NAVY SKI CLUB (LODGE), THREDBO NSW

COMBINED ACCESS AND BCA 2022(A2) ASSESSMENT DEVELOPED FOR AUTHORITY REVIEW

REPORT NO: 3115 - REV A **DRAFT**

Figure 19 - Lower Level, openings within 3m of the allotment boundary

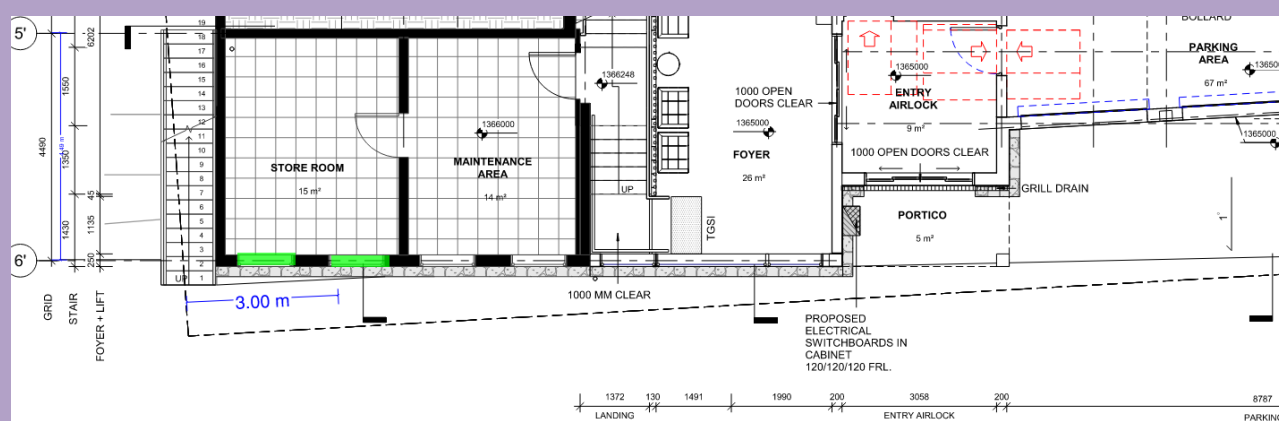
BCA Clause:	Compliance achieved	Compliance Review:	Design Recommendation:
systems		remainder of the building via construction achieving an FRL of 120/120/120. The site inspection and design documentation does not propose to incorporate any electrical substation or similar.	proposed within the building compliance with this clause is required to be incorporated within the Construction Certificate documentation.
BCA Clause C3D15 – Public corridors in Class 2 and 3 buildings	Compliance is achieved	In a Class 3 building, a public corridor if more than 40m in length must be divided at intervals of not more than 40m with smoke-proof walls complying with S11C2. The public corridors are not proposed to exceed 40m.	Compliance with this clause is achieved.
BCA Clause C4D3 – Protection of Openings	Existing and new non-compliance Performance Solution is required to achieve compliance.	If the distance between an opening and the fire source feature to which it is exposed to is less than 3m from the side or rear boundary of the allotment, 6m from the far boundary of a road, river, lake or the like adjoining the allotment, if not located in a storey at or near ground level or 6m from another building on the allotment that is not a Class 10 building the openings are required to be protected in accordance with BCA Clause C4C5. The existing and proposed works comprise of openings located within 3m of the allotment boundary. Where doorways discharging to the external stairs, compliance should be achieved via a -/60/30 self-closing fire door. The affected openings are shown below marked in green on each level:	A Fire Engineered Performance Solution is required to address these openings (proposed and existing). It is noted that the Fire Engineering Report would rely on multiple methods of achieving compliance including Crimsafe attenuation screens or similar.
